Project	<b>IEEE 802.16 Broadband Wireless Access Working Group</b> < <a href="http://ieee802.org/16">http://ieee802.org/16</a> >	
Title	<b>Identifying the correct TEK in the TEK State Machine</b>	
Date Submitted	<b>2005-10-06</b>	
Source(s)	David Johnston Intel Corporation Hillsboro, OR USA	Voice: 502 264 3855 Fax: <a href="mailto:dj.johnston@ieee.org">mailto:dj.johnston@ieee.org</a>
Re:	Reply comment to 8001 of the 802.16e recirculation ballot	
Abstract	A proposal to disambiguate the key that is being referred to in the TEK state machine	
Purpose	To correct errors in the TEK state machine.	
Notice	This document has been prepared to assist IEEE 802.16. It is offered as a basis for discussion and is not binding on the contributing individual(s) or organization(s). The material in this document is subject to change in form and content after further study. The contributor(s) reserve(s) the right to add, amend or withdraw material contained herein.

# Identifying the Correct TEK in the TEK state machines

*[Replace Figure 134 TEK Management in BS and SS on page 293 with:]*

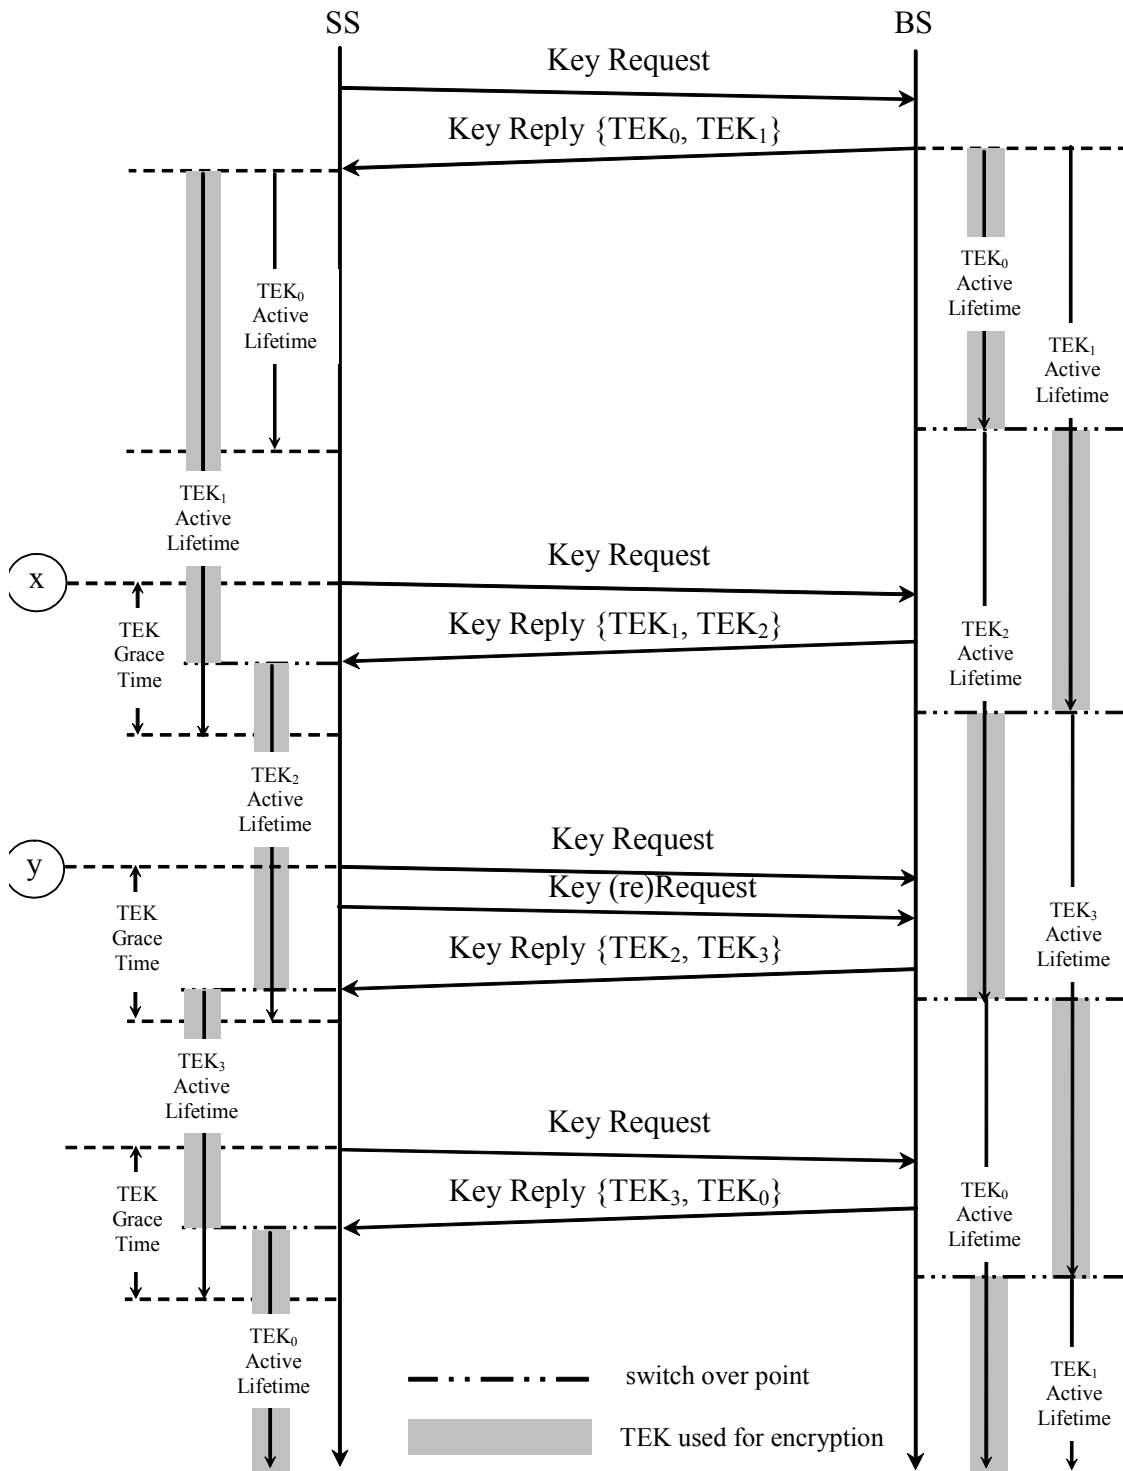
The text of the TEK state machine is unclear about what key is being referred to in the key update. The insertion of the work 'newer' in states 8-B and 8-E, along with a change to the diagram clear this up.

- a) Clear Key Request retry timer
- b) Process contents of Key Reply message and incorporate new keying material into key database
- c) Set the TEK refresh timer to go off "TEK Grace Time" seconds prior to the newer key's scheduled expiration

- a) Clear Key Request retry timer
- b) Process contents of Key Reply message and incorporate new keying material into key database
- c) Set the TEK refresh timer to go off "TEK Grace Time" seconds prior to the newer key's scheduled expiration
